MAZDA DEALER EMAIL

Subject: Launch of Safety Recall 4621B - 2020-2021 CX-30 vehicles – Power Liftgate May Partially

Lower Unexpectedly

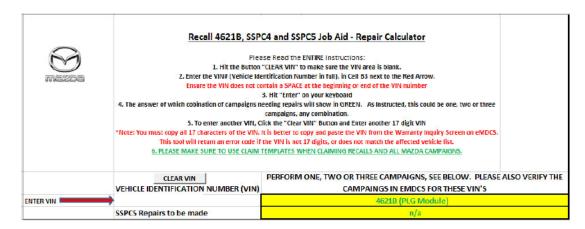
Due to an improper frictional retaining force of certain power liftgate drive motor units, as well as a reduction in the liftgate support spring force in high ambient temperatures, the power liftgate may slowly lower slightly from the fully opened position when parked on an incline. A person accessing the rear storage area of the vehicle may unexpectedly hit the liftgate and increase the risk of injury if the power liftgate partially lowers from the fully opened position when parked on an incline in high ambient temperatures. There is no risk of the liftgate unexpectedly lowering completely as a result of this defect.

The power liftgate drive units (both right and left) must be inspected for the product lot number. If the power

liftgate drive unit(s) is verified to be included in the affected production range, it will be replaced with an improved part. After the inspection, and/or replacement of the power liftgate drive units is completed, the MDRT will be used to update the power liftgate control unit with modified software.
